# UNITED STATES PATENT AND TRADEMARK OFFICE

APPLICATION NO.	FILING DATE	FIRST NAMED INVENTOR	ATTORNEY DOCKET NO.	CONFIRMATION NO.
09/845,782	04/30/2001	Bret L. Howell	TE2-090	4357

## Office Action Summary

**FIG. 9***Response to Arguments*

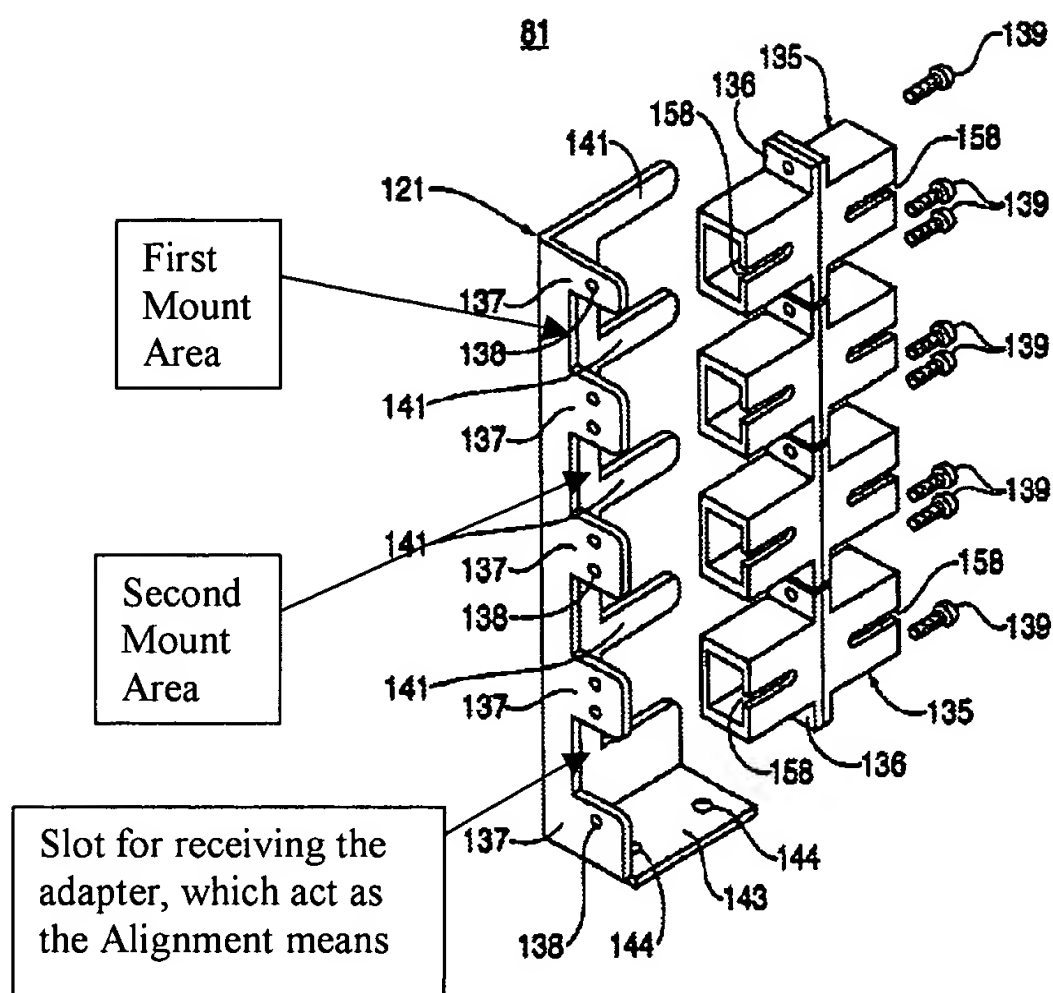
14. Claims 20-22 are rejected under 35 U.S.C. 103(a) as being unpatentable over Allen, Glover et al and Koopman et al as applied to claims 19 and 23-28 above, and further in view of Puetz.

Claim 20 recites the same limitation as claim 7 and claims 21-22 recite the same limitations as claims 8-9. Therefore, the same rejections applied to claims 7-9 in the above paragraph 11 also apply to claims 20-22. Thus, the examiner will not repeat the rejection.

15. Claim 27 is rejected under 35 U.S.C. 103(a) as being unpatentable over Kusuda et al (6,644,866 B1).

Kusuda discloses a fiber optic cable adapter holding structure 81 comprising a first adapter mount area and a second adapter mount area, each mount area configured to receive SC-type adapter 135. Each mount area includes an alignment means (a slot for receiving the adapters on the attachment surface 137) to position the adapter and an attachment means 138 and 139 to secure the adapter to the mount area. Although Kusuda does not disclose FC-type adapter to be attached on the adapter mount area, Kusuda teaches in the prior art Figure 31b that FC-type adapter can be used.

It would have been obvious at the time the invention was made to a person having ordinary skill in the art to modify the adapter holding structure taught by Kusuda such that it would attach FC-type adapter as taught by the prior art of Kusuda because it only deals with using one type of known adapter over the already known other type adapter.
